CONGRESS SQUARE REDESIGN STUDY GROUP

Memorandum
Planning and Urban Development Department
Planning Division

Re: Congress Square Plaza proposal assessment

Meeting Date: Wednesday, May 22, 2013

May 2013 Proposal
Diagram 4

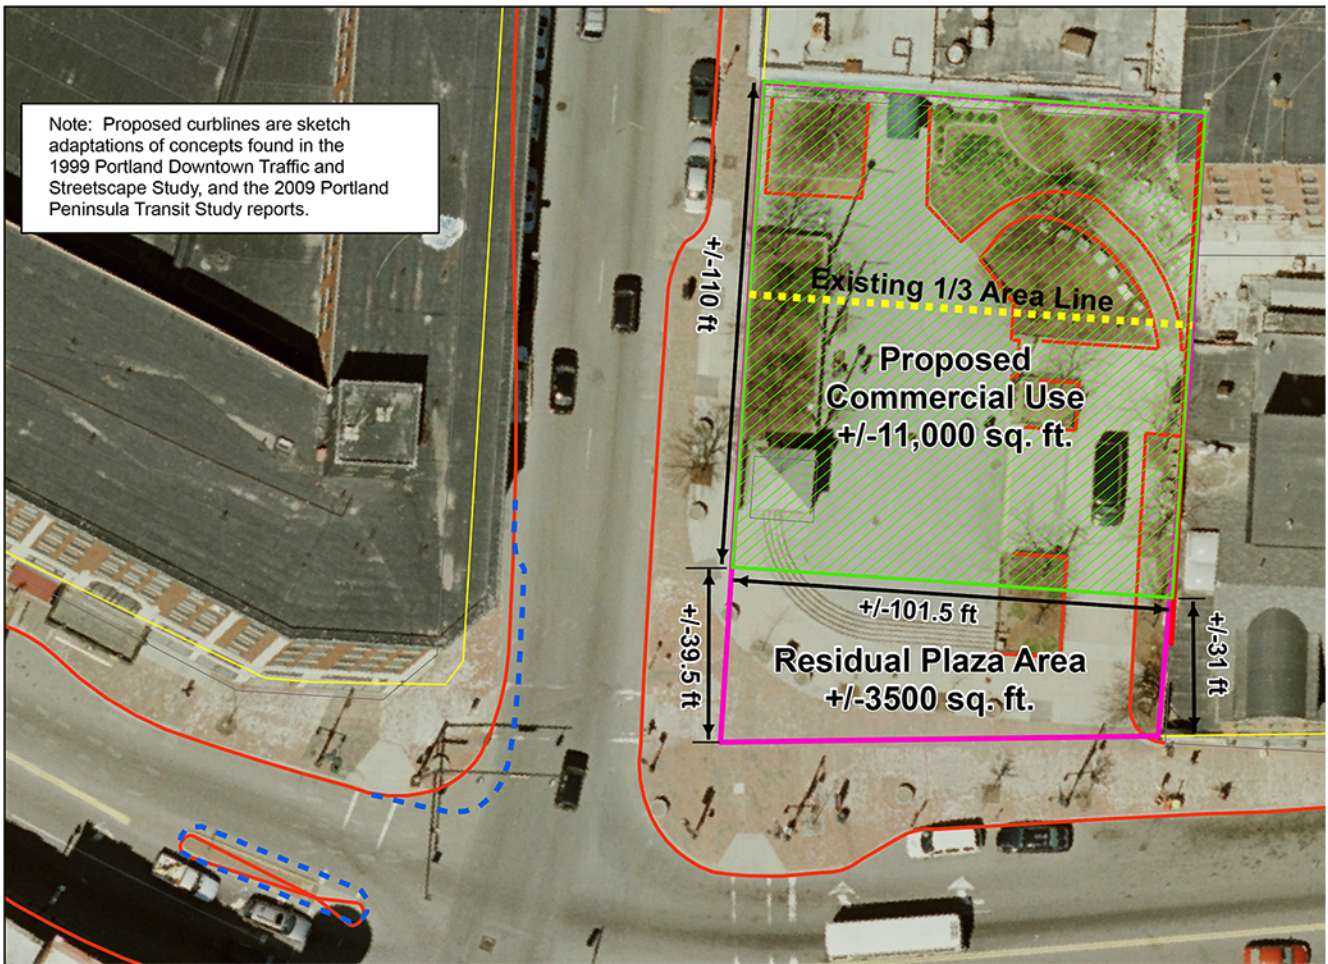
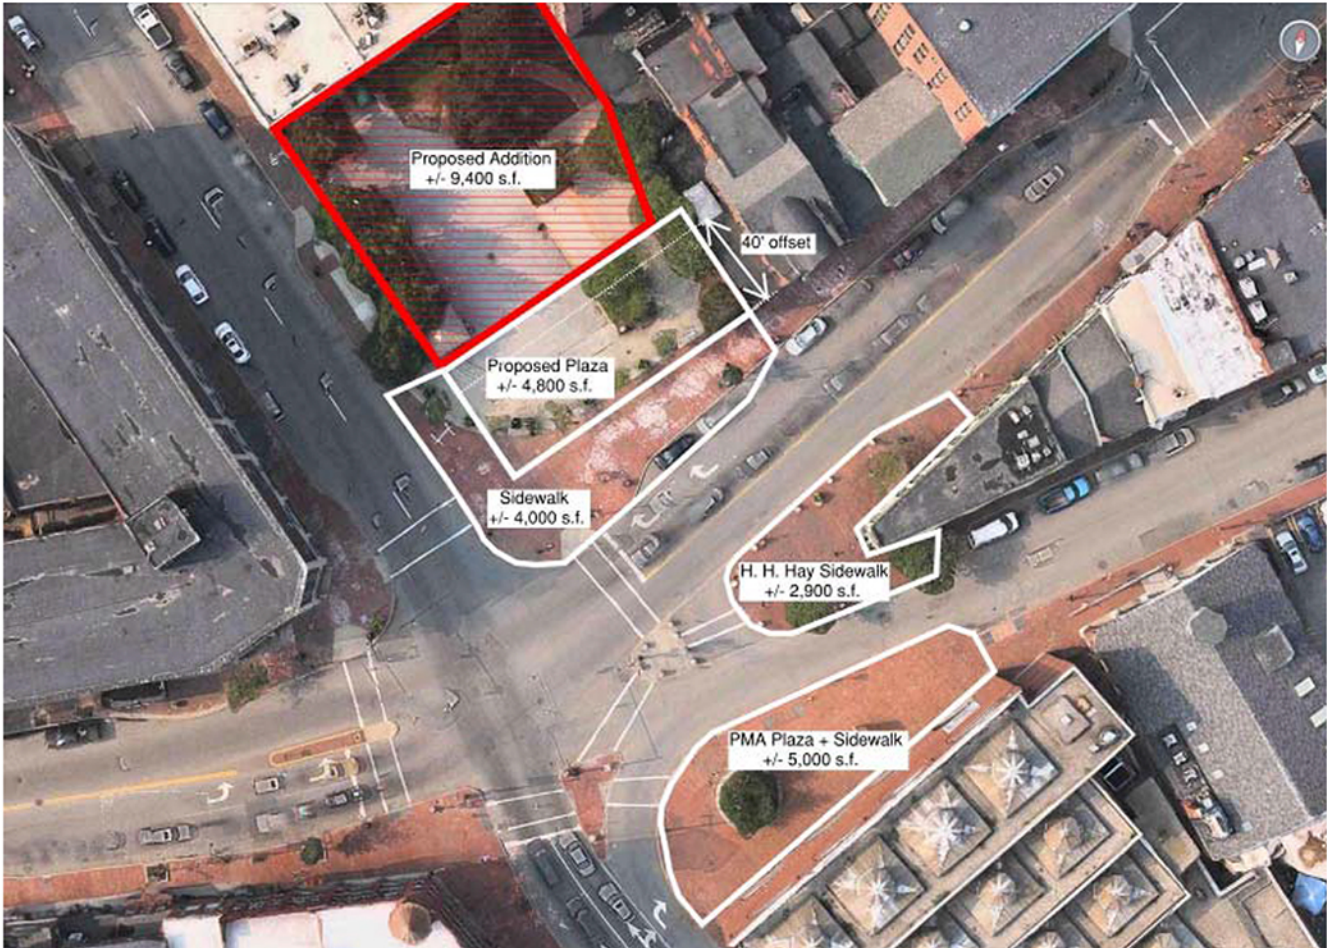
There are two primary differences between the August, 2012 proposal and the current proposal. First, the size of the proposed event center building has been reduced from 11,100 square feet to 9,400 square feet leaving more of the parcel to remain public plaza space. The previous proposal allowed for 3,500 square feet of plaza space compared to the current proposal which accommodates 4,836 square feet for public plaza. (Diagram 4) The second difference between the two proposals is the architecture of the building itself, specifically, the building is contextual and interfaces with the public realm. In the recent proposal, the building has a glass façade with habitable and hopefully interactive space bringing activity and visibility to the plaza whereas the previous proposal had blank and solid walls facing the plaza (Diagram 5). The additional advantage to the recent proposal is the gallery-like space which may include art and public function space. The lighting of the glass gallery at night can bring added interest and safety to the plaza.

Diagram 7
 May 16, 2013 Proposal
 NTS

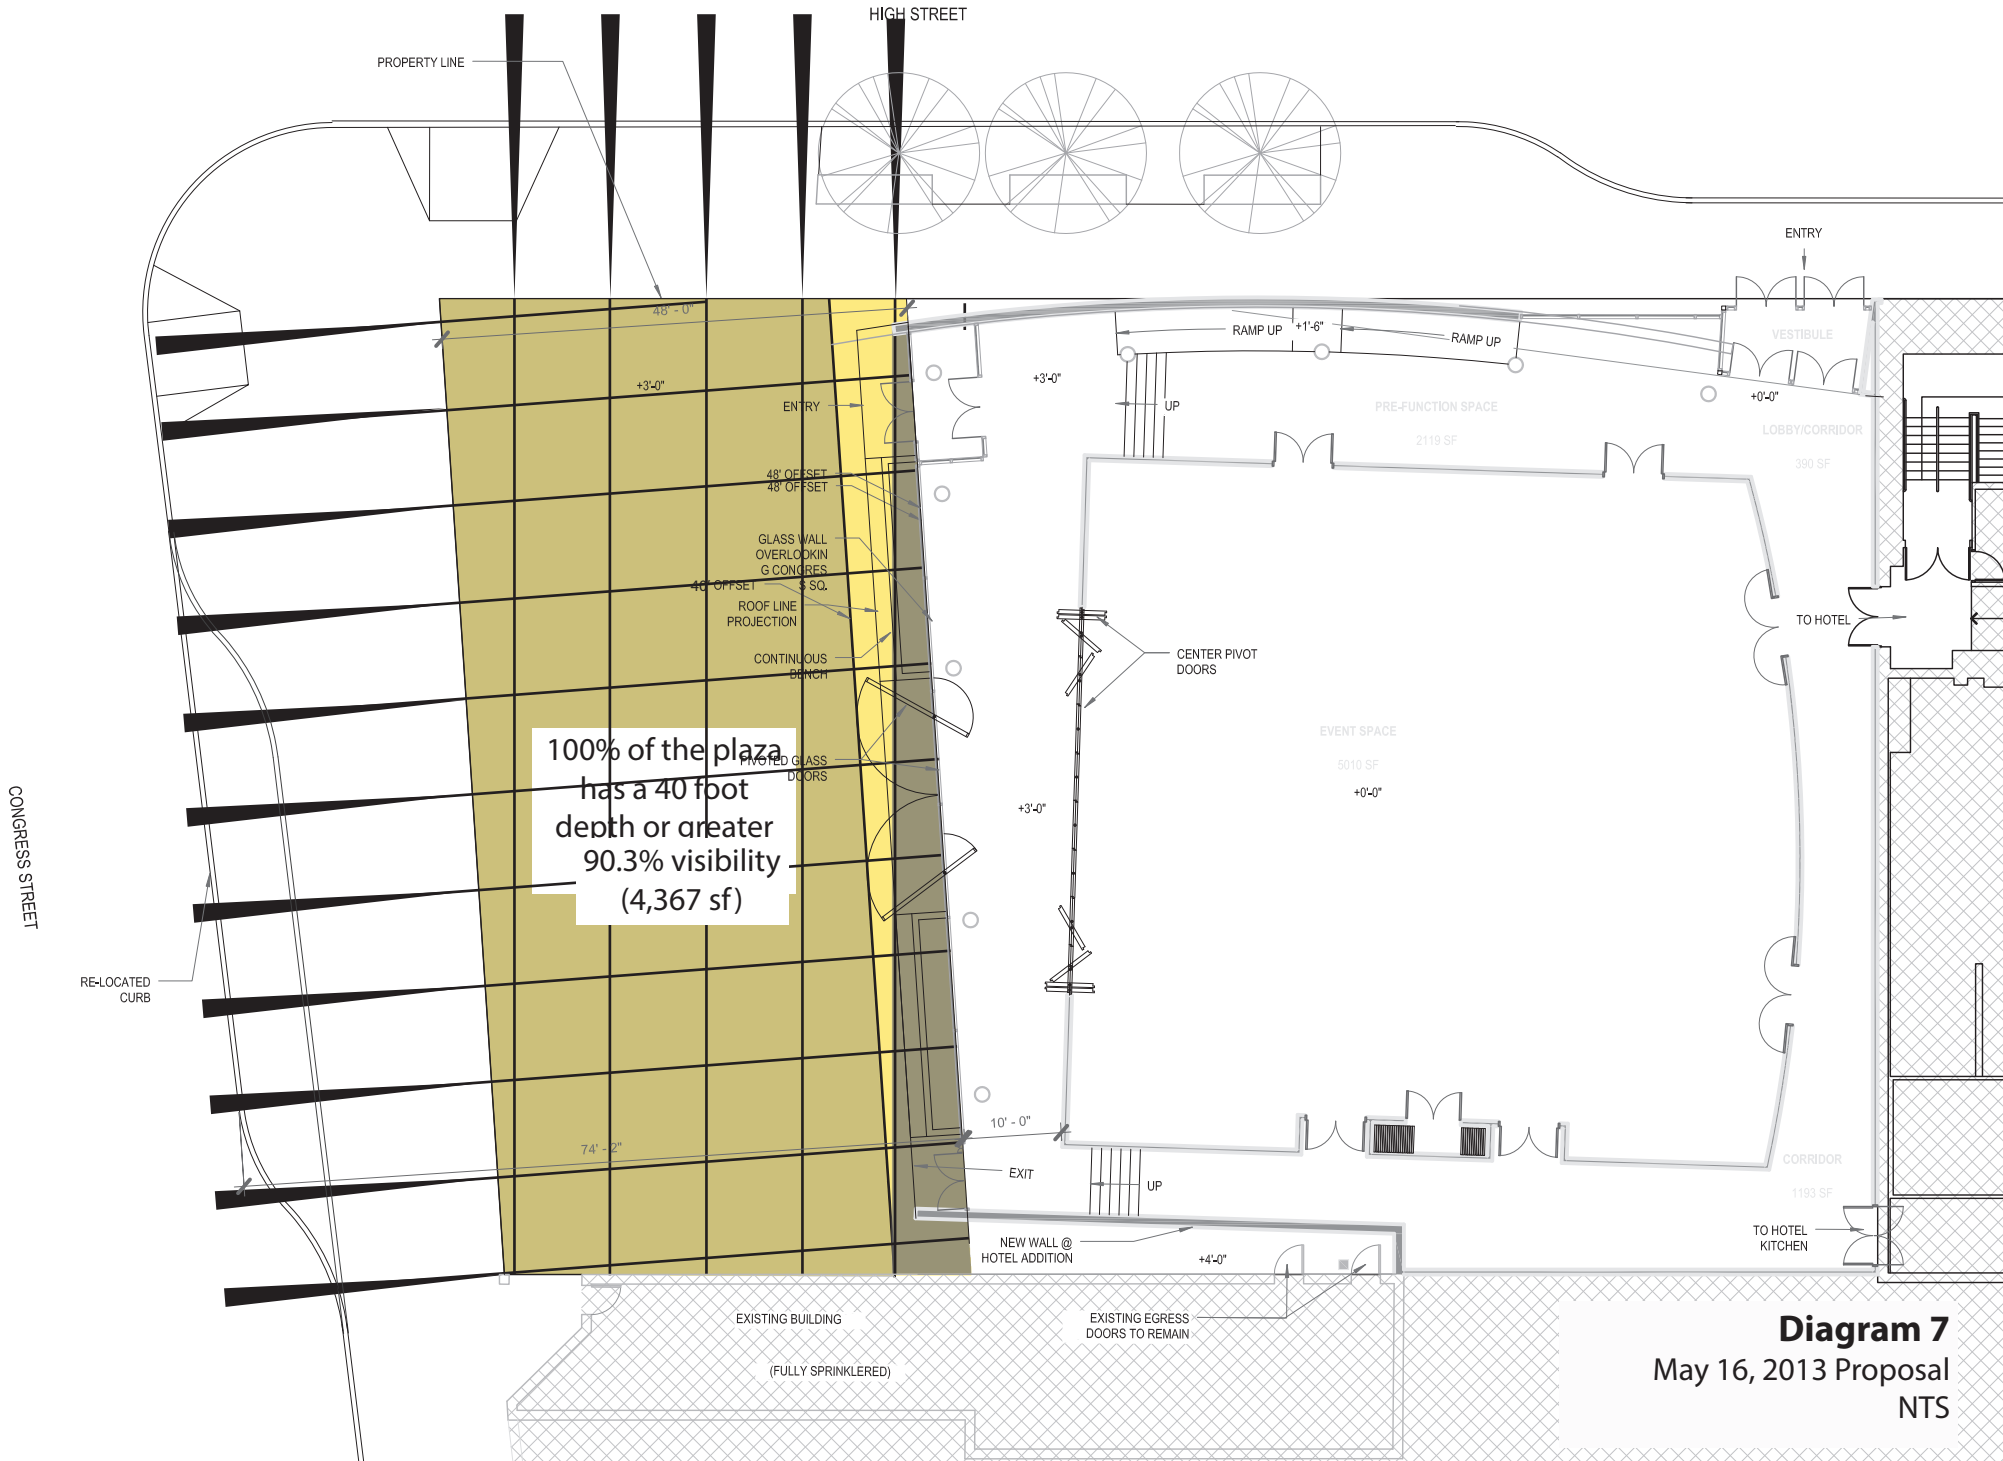
Assessment of the revised (May 16) proposal (Diagram 7) compared to the April 24th proposal (Diagram 6) shows that the plaza meets all of the NYC Plaza Standards. The distance from property line to edge of glass has been increased to 48 feet resulting in an increase of 536 square feet to the plaza. The new position of the building also increases visibility to and within the plaza. The wing walls, canopy, and benches associated with the proposal have been reduced in size. Staff feels that the quality of the public plaza is enhanced by further iteration and design development of the proposal. For example, with the setback of the building to 48 feet the proposal creates a space more hospitable for a sidewalk café for the neighboring retail business. Increased physical access by making the glass wall operable potentially increases interaction between the public and private realm.
